Staff Report

To: Salt Lake City Planning Commission
From: Aaron Barlow, Principal Planner, aaron.barlow@slcgov.com, 801-535-6182
Date: November 16, 2022
Re: PLNPCM2022-00708 & PLNPCM2022-00709 – SPARK! Mixed-Use Development

Design Review & Planned Development

PROPERTY ADDRESS: 1500 West North Temple

KEY NOTES - LEVEL 1

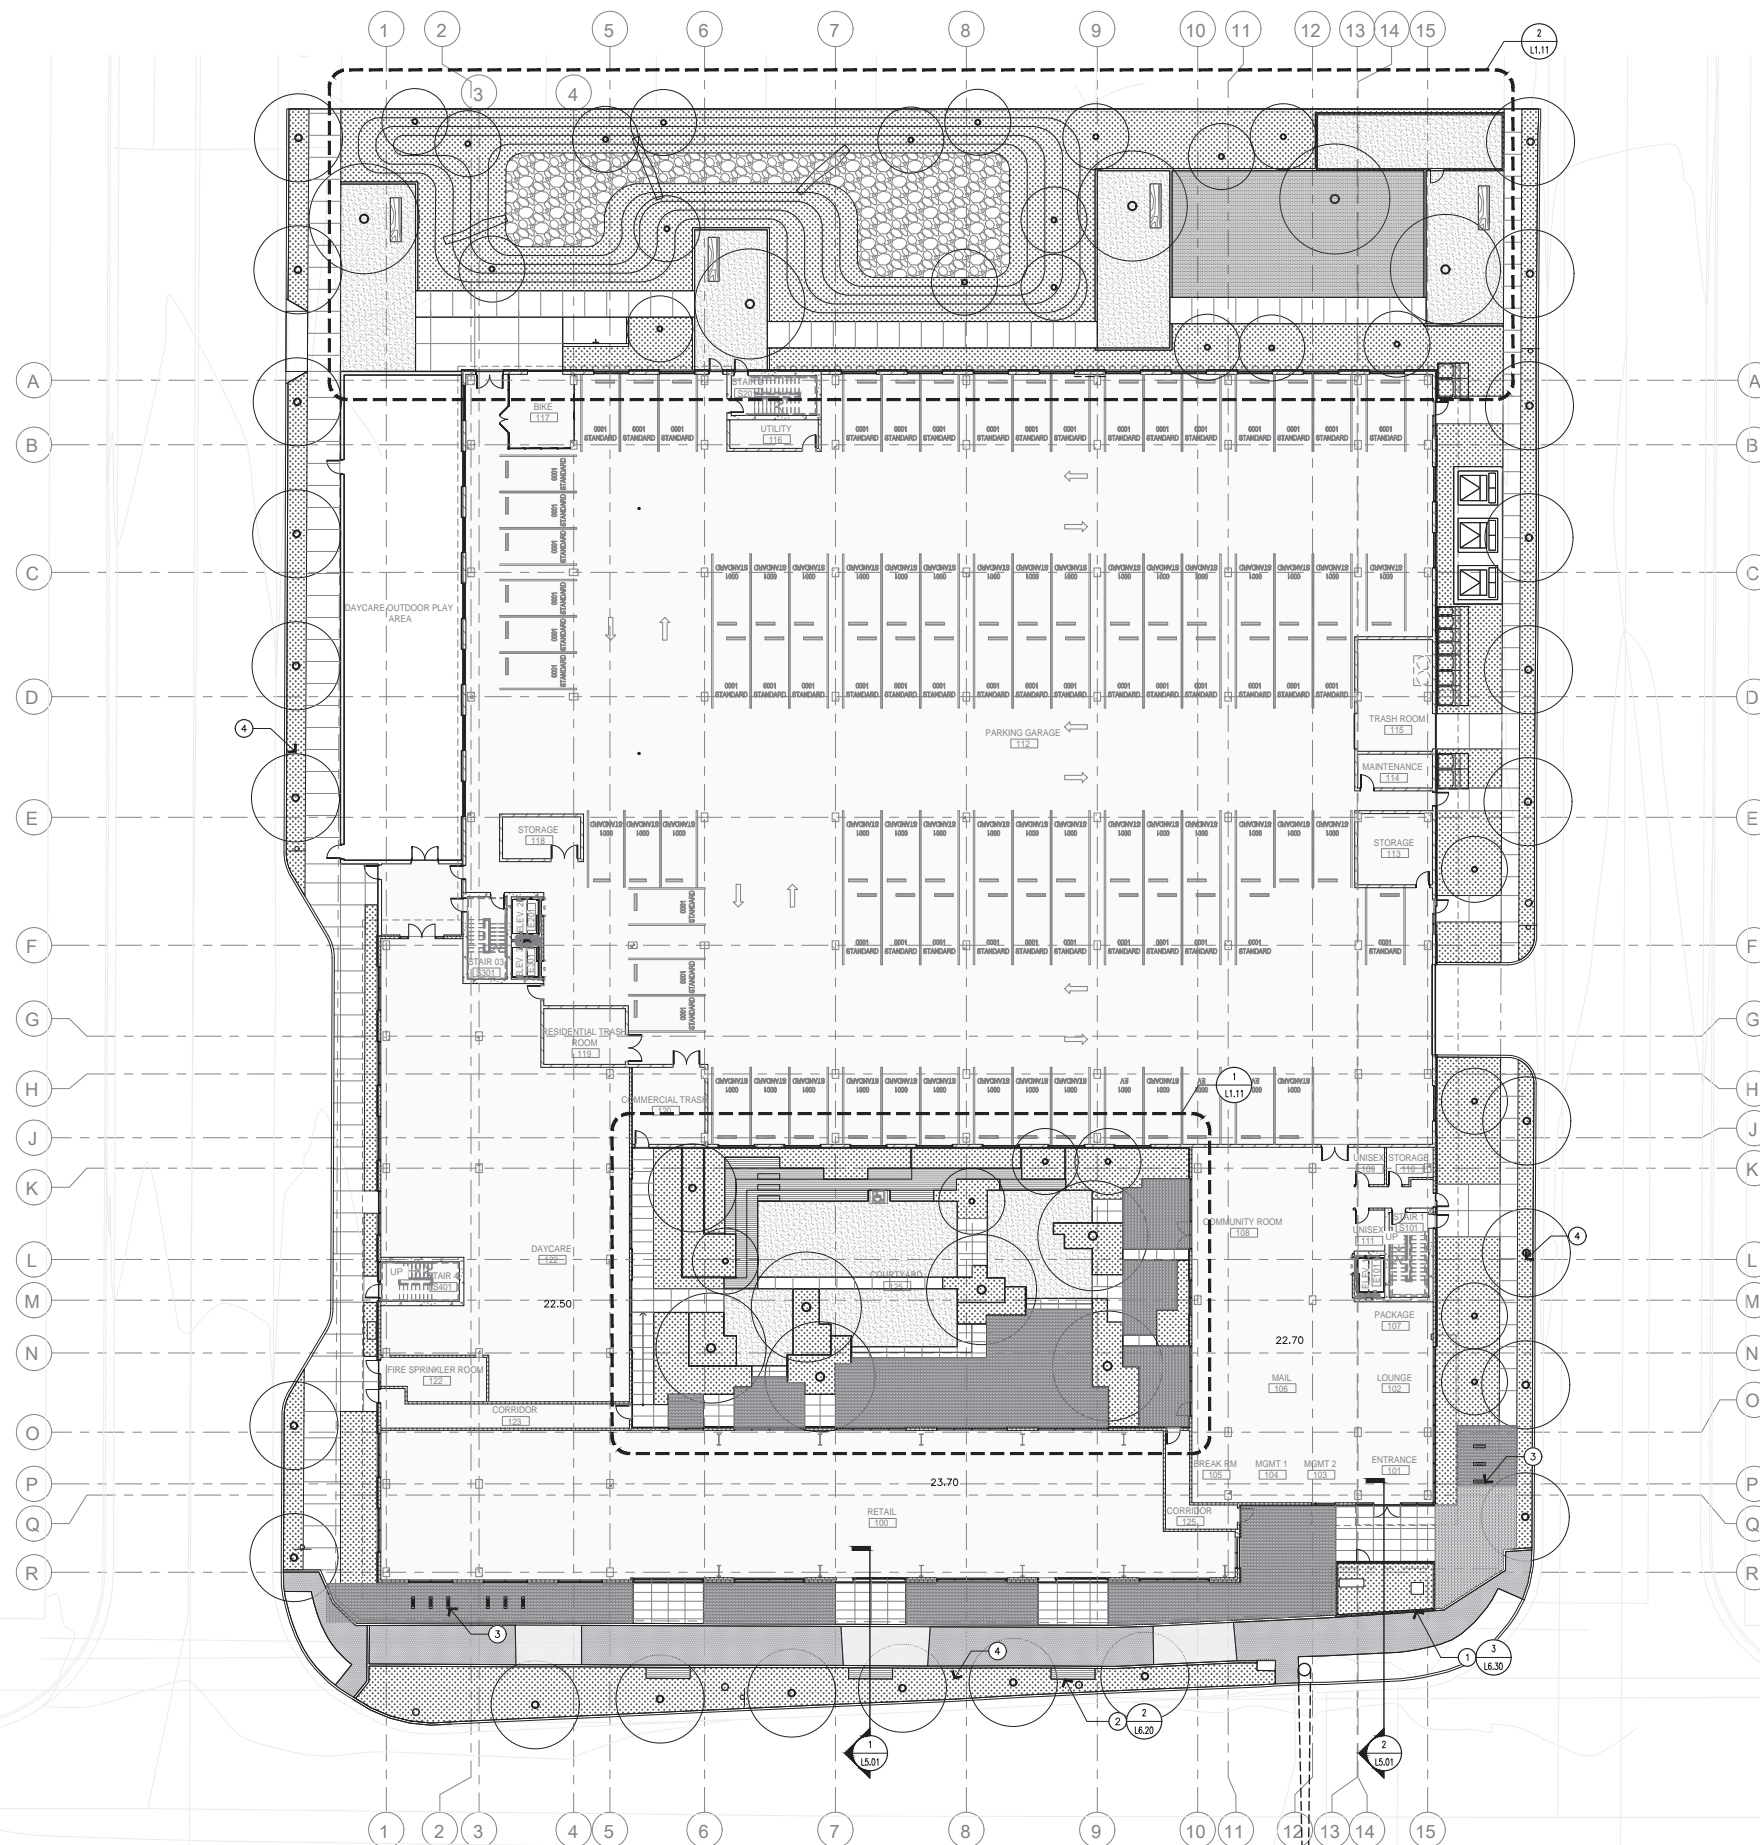
Discussion: The Planned Development process is being requested because a portion of one façade of the building does not meet the minimum height requirement and additional fence height is requested in order to screen utility boxes. Modification to the height requirement allows modulation of the front façade. The two ends of the building are taller and meet the height regulation. Allowing the center portion to be slightly lower than what is required will provide a bit of an open feeling. Allowing the additional fence height would allow for an artistic element to screen utility boxes. Overall, the project helps to implement many planning goals by providing affordable housing, providing a daycare, and incorporating a mid-block greenway.

BUILDING LENGTH DIAGRAM - SOUTH ELEVATION SCALE: 3/32" = 1'-0" **2**

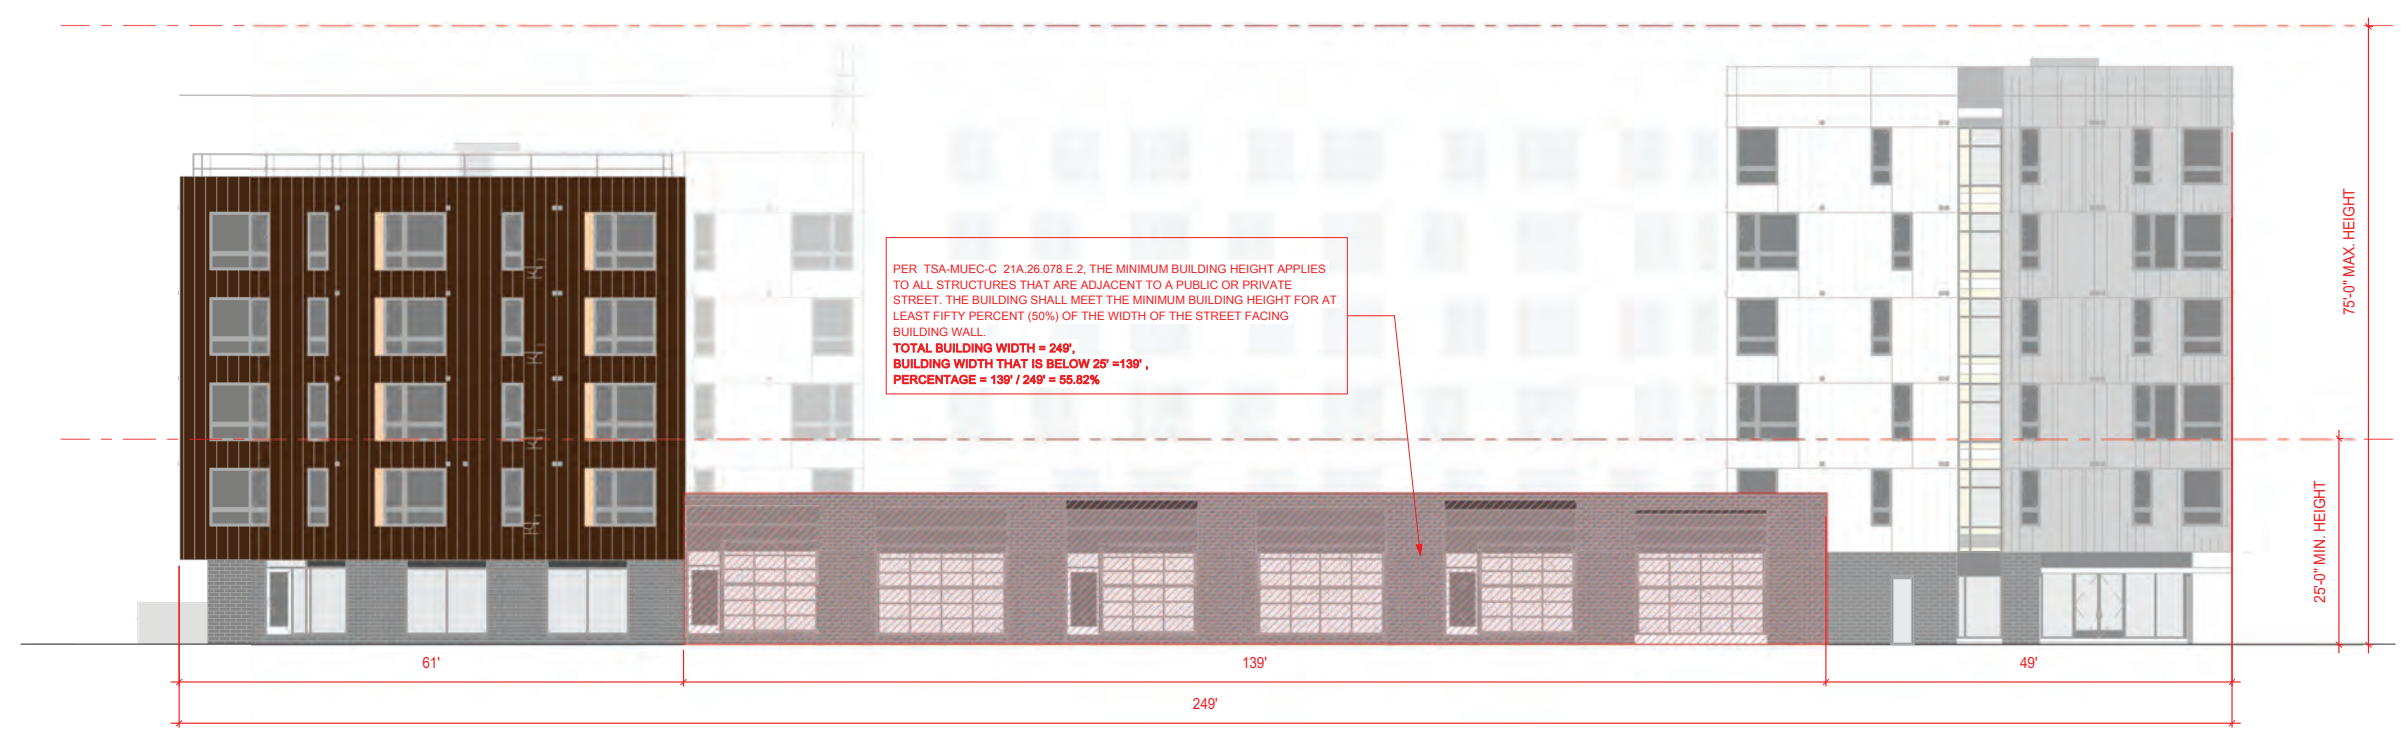
Overall, the project is consistent with the TSA zoning regulations as they related to scale, mass, and intensity. Although the project requires a modification to the minimum height standards for street facing facades, the ask is minimal. The ordinance regulation requires at least 50% of the street facing façade to be at least 25 feet in height. In this case, the under-height segment accounts for approximately 56%, which is a minimal adjustment.
